**2908 Yonge Street - Zoning By-law Amendment
Application – Refusal Report**

Date:	March 27, 2018
To:	North York Community Council
From:	Director, Community Planning, North York District
Wards:	Ward 16 – Eglinton-Lawrence
Reference Number:	17 277147 NNY 16 OZ

Attachment 1: Site Plan

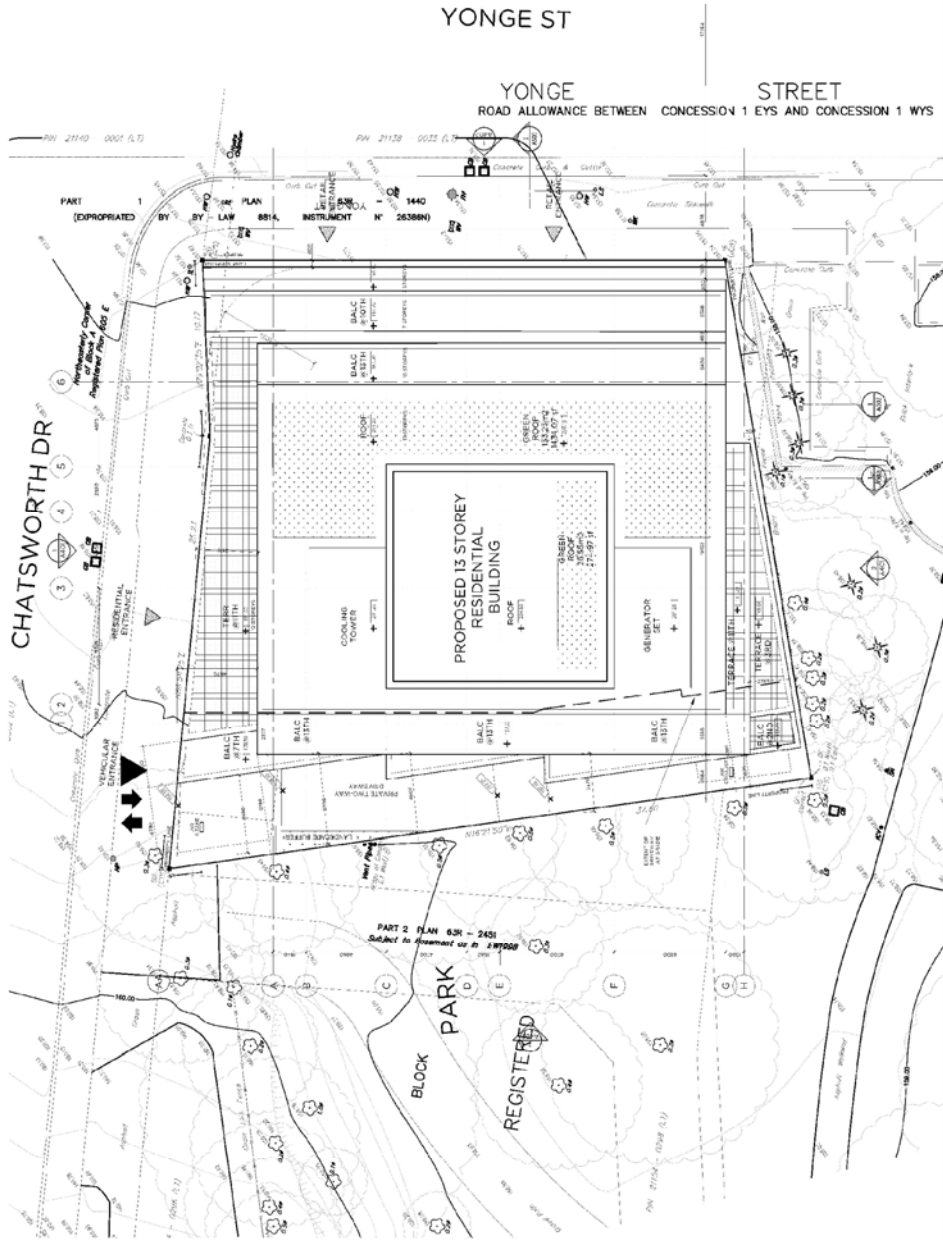
The applicant proposes to construct a 13-storey mixed-use building containing 85 residential units and a total of 421.8 square metres of commercial space on the ground floor and mezzanine level. A total of 8,559 square metres of gross floor area is proposed which would result in a density of 7.77 times the lot area. The proposed height of the building to the top of the main roof would be 44.20 metres while the proposed height to the top of the mechanical penthouse would be 47.8 metres. A total of 70 parking spaces are proposed in a 4-level underground parking structure (See Attachment 1: Site Plan).

While the plans are not dimensioned, the below-grade parking garage appears to be set back from the south and west lot lines (which coincide with city park land) approximately 0.5 metres. The north face of the underground parking garage is proposed to have a zero lot line setback from the Chatsworth Drive property line while the proposed setback of the underground parking structure from the Yonge Street lot line is also proposed to be zero metres from the existing lot line.

The anticipated road allowance for Yonge Street in this location is a 27.0 metre right-of-way. Given this, a road widening of 0.4 metre is required of the applicant along the Yonge Street property line. A corner rounding with a 6.0 metre radius would also be required at the corner of Chatsworth Drive and Yonge Street. The applicant has shown both the road widening and the corner rounding on the plans of the proposed development. Portions of the building would encroach into the corner rounding both below and above grade. Once the required road widening is taken along Yonge Street the underground parking garage would appear to encroach into the public right-of-way.

The anticipated road allowance for Yonge Street in this location is a 27.0 metre right-of-way according to the Official Plan Map 3 Rights-of-Way Widths Associated with Existing major Streets. Given this, a road widening of 0.4 metre is required of the applicant along the Yonge Street property line. A corner rounding with a 6.0 metre radius would also be required at the corner of Chatsworth Drive and Yonge Street. The applicant has shown both the road widening and the corner rounding on the plans of the proposed development. The applicant's plans appear to show the parking garage encroaching into the 0.4 metre wide road widening. Portions of the building also encroach into the corner rounding both below and above grade. Required road widening and corner roundings must be clear of any encroachments below and above grade.

Attachment 2: Ground Floor Plan

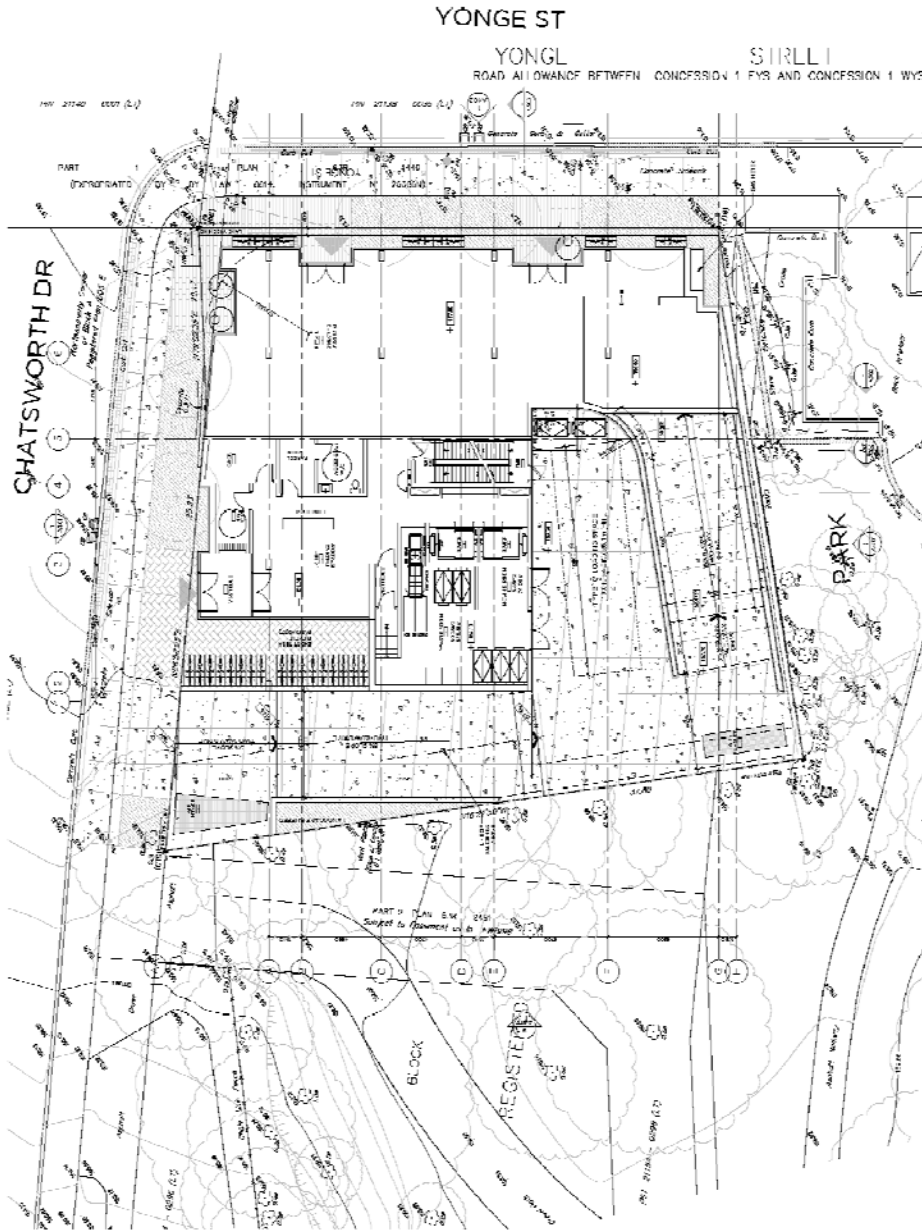
A retail component of 296.07 square metres would be located along the entire Yonge Street frontage with a 125.11 square metre mezzanine level provided above. The remainder of the building at grade would contain ancillary uses to the main residential use such as the lobby entrance/concierge, elevators, mail room, moving room, solid waste management room and loading area (See Attachment 3: Ground Floor Plan).
